ADDENDUM #2

Date:	25 March 2008	
To:	General Contractors	
From:	Bill Bowen, Project Manager, DFCM	
Reference:	Weber State University Hurst Center for Lifelong Learning	
DFCM Project #:	07110810	
Subject:	**Addendum No. 2**	
Pages:	Addendum	1 page
	Substitution Request	16 pages
	Architectural Addendum	38 pages
	Total Pages	**55 pages**

A5 GUARDRAIL @ LANDING

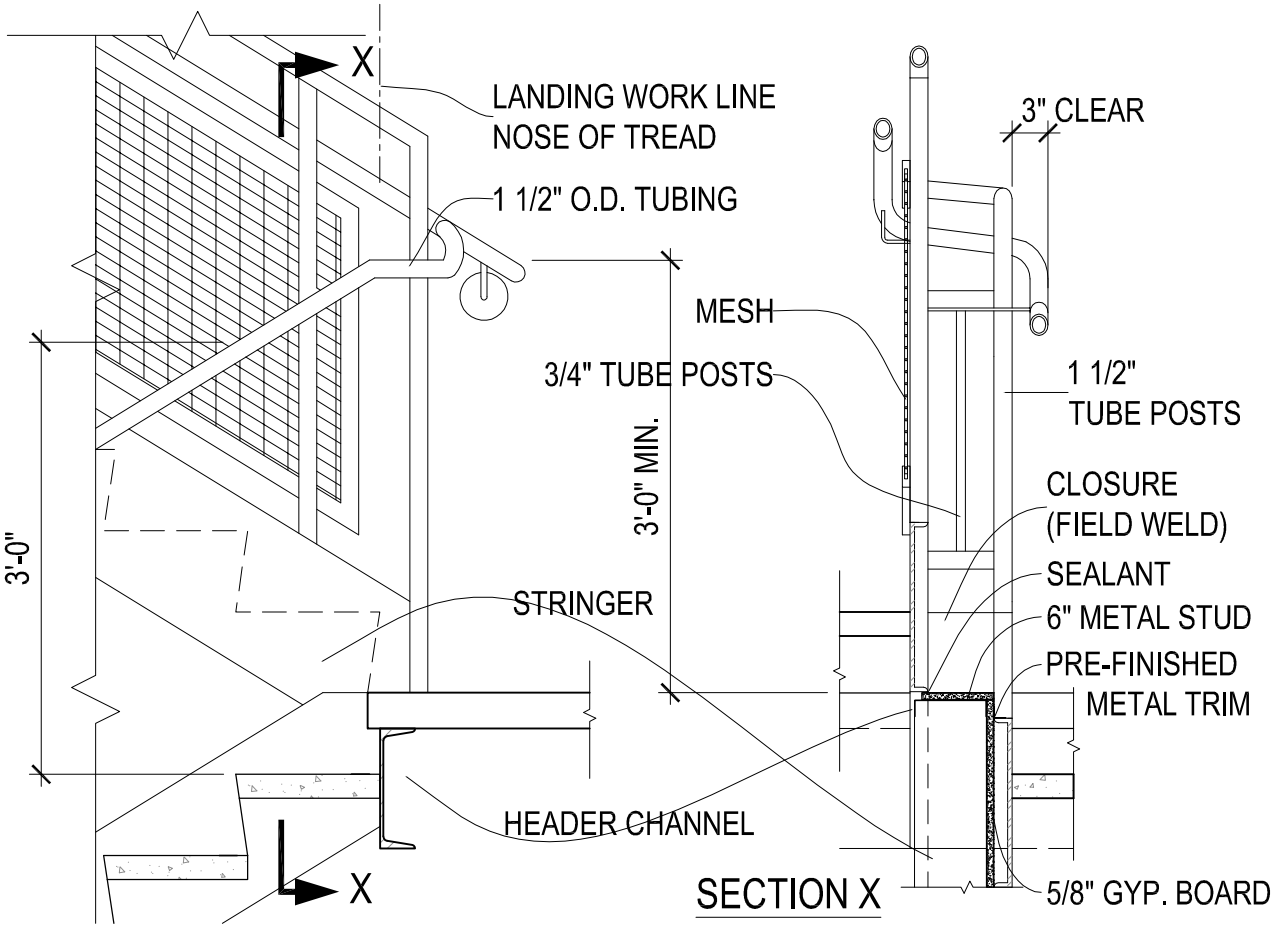
A2.42 Sheet AE530 – add new detail A5/AE530 see sketch AD02-A07.

AE461

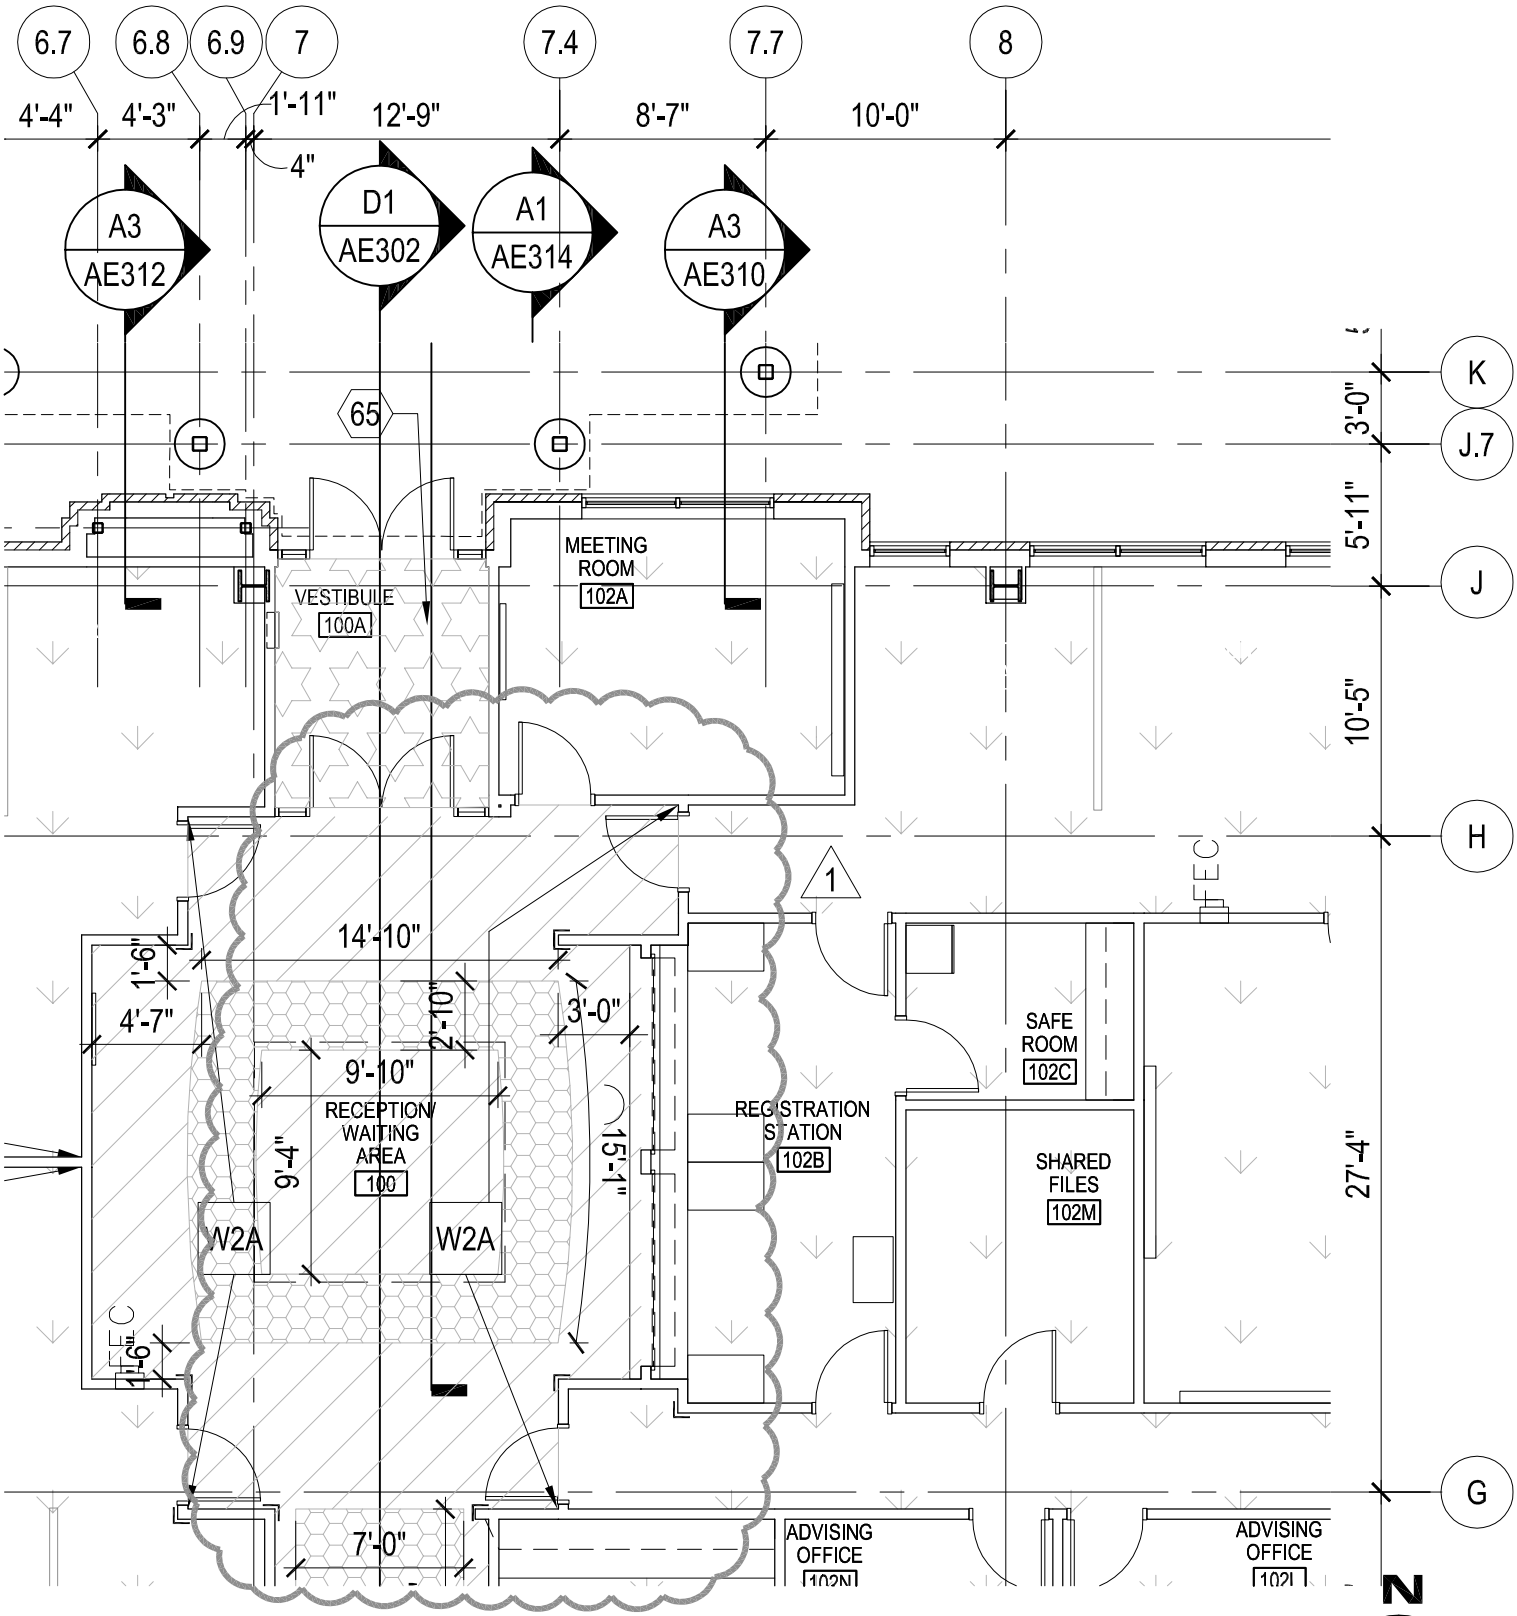
A2.43 Sheet AE461: Refer to sketch AD02-A03 for revisions to floor materials at doors 102 and 102A.

D3 DOOR JAMB DETAIL (HEAD SIM.)

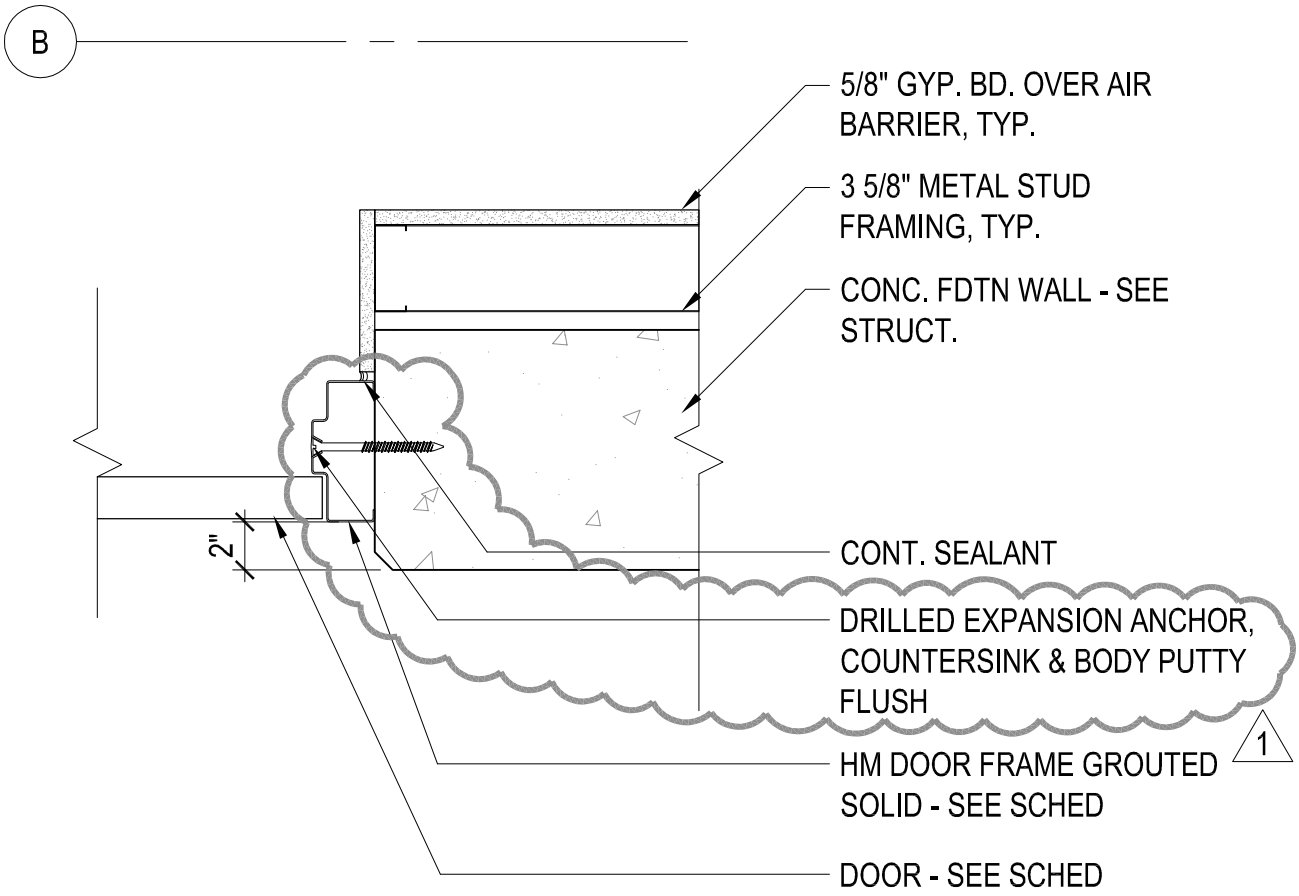
- Detail D3/AE502 – refer to sketch AD02-A04 for revisions to detail.
